Re: Florida Power & Light Company
St. Lucie Units 1 and 2, Docket Nos. 50-335 and 50-389

NextEra Energy Quality Assurance Topical Report (FPL-1) Revision 24 Annual Submittal

NextEra Energy Quality Assurance Topical Report Change Summary May 2020

**Appendix E: Organization Charts
Chart 1 of 2: Corporate**

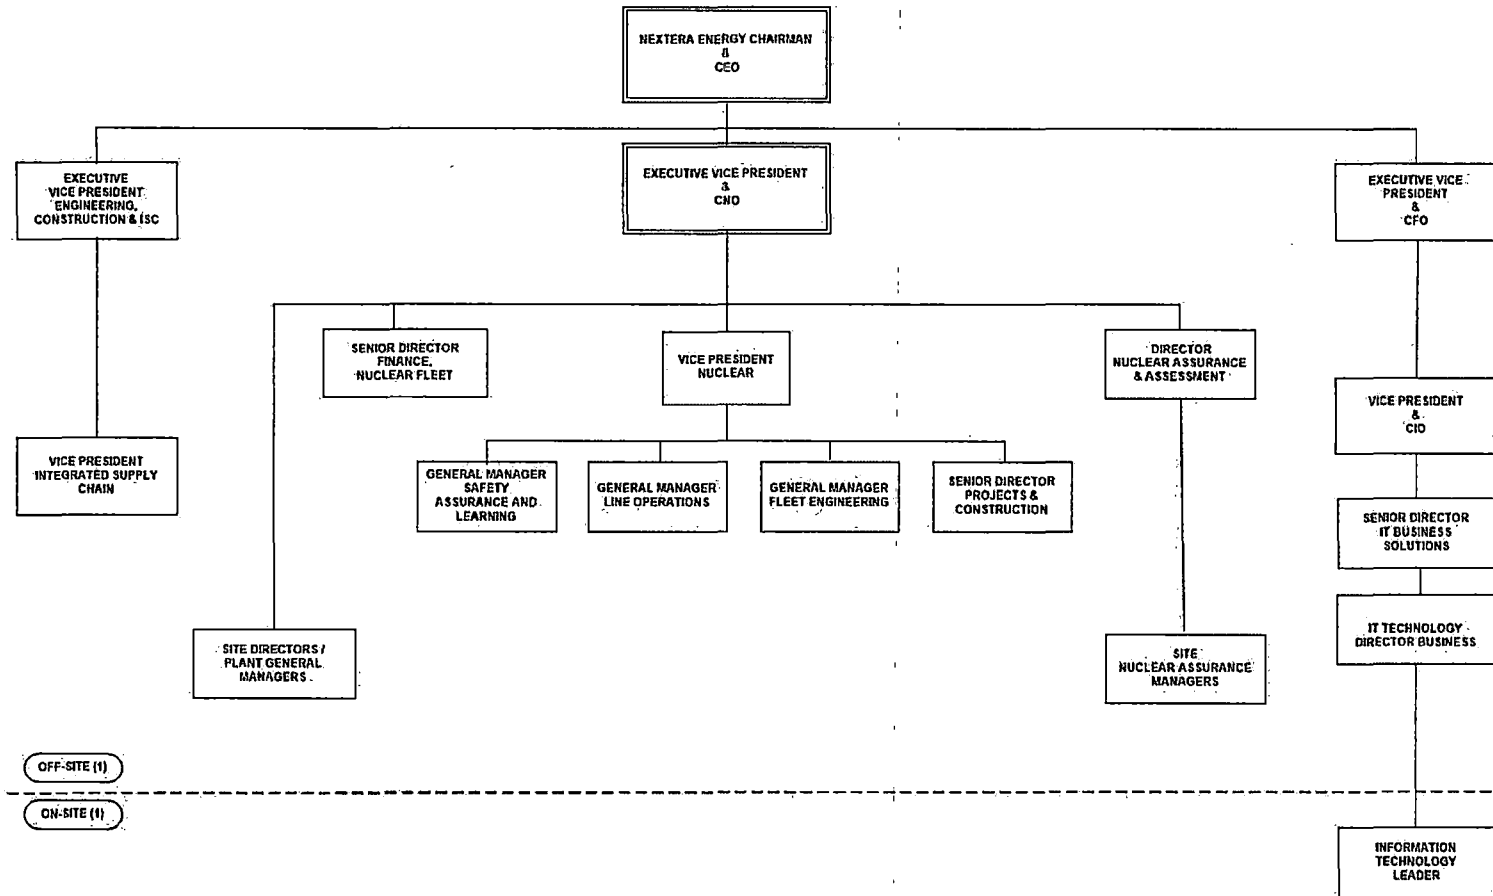
Revision 24	
Change/Reason for Change	Basis for Meeting 10CFR50
<p>QR061: The changes incorporated within this revision include the following:</p> <p>Revise the reporting relationship of the CNO to reflect a direct report to the Chairman and CEO and to reflect responsibility of company officer responsible for ensuring that defects and non-compliances are reported to the NRC.</p>	<p>This change was evaluated in accordance with 10 CFR 50.54 (a) requirements. Revise the reporting relationship of the CNO. QR061 (AR 2350967)</p> <p>Organizational revision and persons and organizations performing quality functions continue to have the requisite authority and organizational freedom, including sufficient independence from cost and schedule when opposed to safety considerations.</p> <p>This change is not considered a reduction in commitment based on the following guidance in NA-AA-210-1000, Attachment 1:</p> <ul style="list-style-type: none">• The use of generic organizational position titles that clearly denote the position function, supplemented as necessary by descriptive text, rather than specific titles.• The use of generic organizational charts to indicate functional relationships, authorities, and responsibilities, or, alternately, the use of descriptive text.
